For use with KTA Strain Phono Pre-amplifier A2.1 only
Copyright KTA/Kevin Kennedy
For personal use only

Sheet: /
File: SG_Phono_EQ_Module1B.sch

Title: Improved SG_Phono EQ Network (For Rev. A2.1 ONLY)

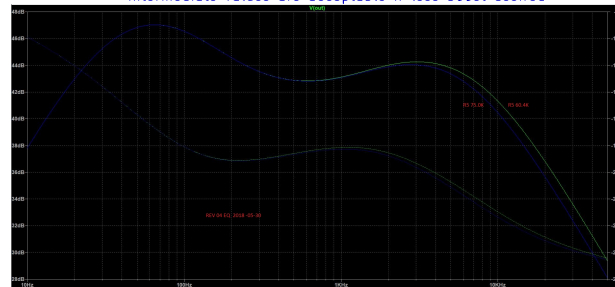
On Phono Pre-amp Card:
Install jumper in place of R11
Change value of C2 to 0.047uF

Change R5 from 75.0K (REV 03) to 60.4K (REV04)
Intermediate values are acceptable if less boost desired
